Device Errata

Skywire™ Raspberry Pi Adapter

NimbeLink Corp

Updated: July 2017

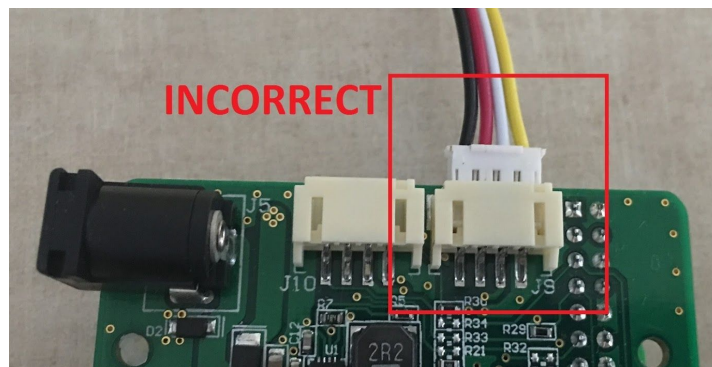
Applications using the Grove connectors on NL-AB-RPI adapter board with PCB revision 1001430 REV A are affected. The grove connector pins are reversed, as shown in the image below. Users who wish to use Grove sensors on affected PCBs must follow the steps outlined in section four of this errata.

Grove sensors using unmodified cables should not be directly attached to the Grove connectors on affected boards as this may cause shorts and/or damage to the sensor or Raspberry Pi.

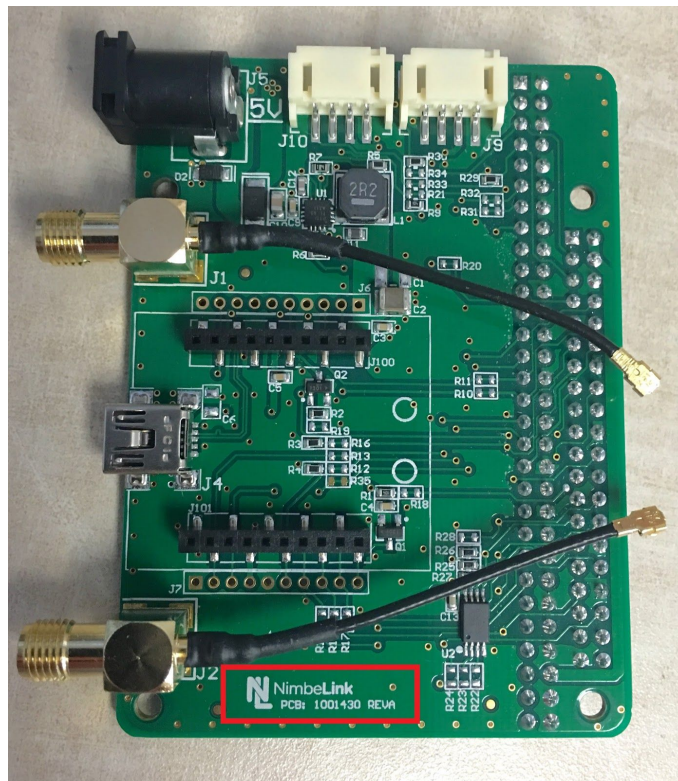
The PCB revision number is located on the bottom of the top side of the PCB. This Errata affects all NL-AB-RPI boards with a PCB revision number of 1001430 Rev A.
